Cross-band repeater controller  
 by Patrick Schlott, KC1DPM  
 February 2021

xbr
2021-04-28 14:26:04
Sheet: 1/1

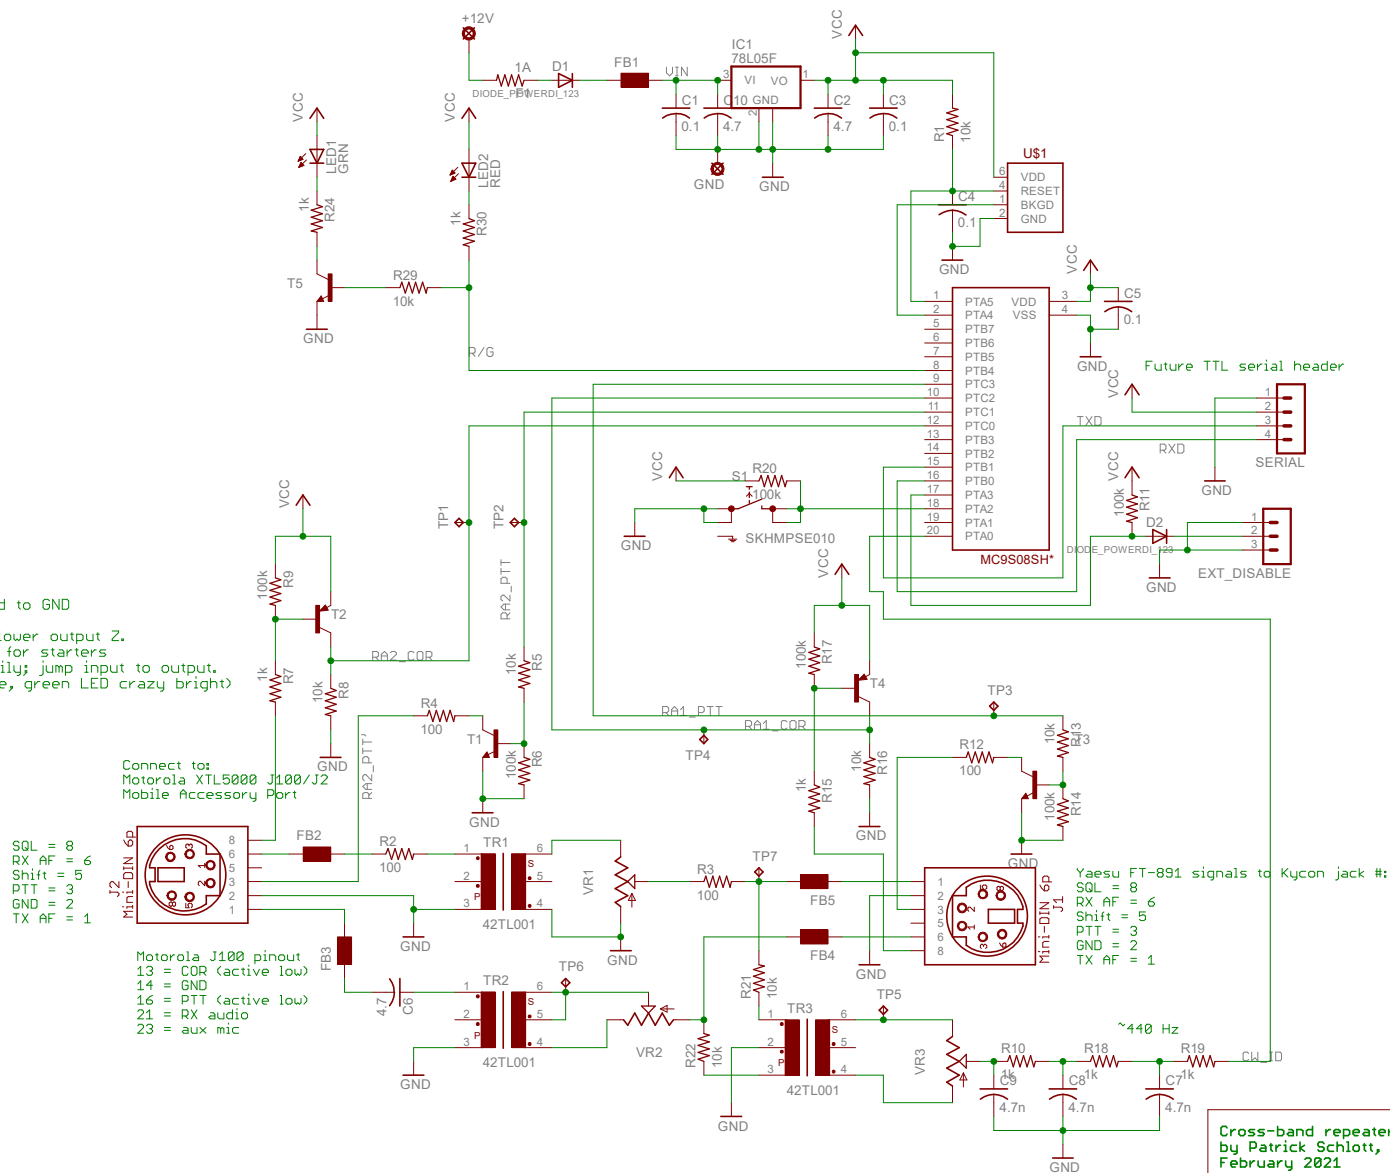
Errors and fixes:  
 - TR2 and TR3 are not referenced to GND on the secondary.  
 - 3-pole filter needs to have a lower output Z.  
 - Use 1k resistors and 470nF caps for starters.  
 - TR2 loads the mic ckt too heavily; jump input to output.  
 - Increase R24 to 10k (preference, green LED crazy bright)
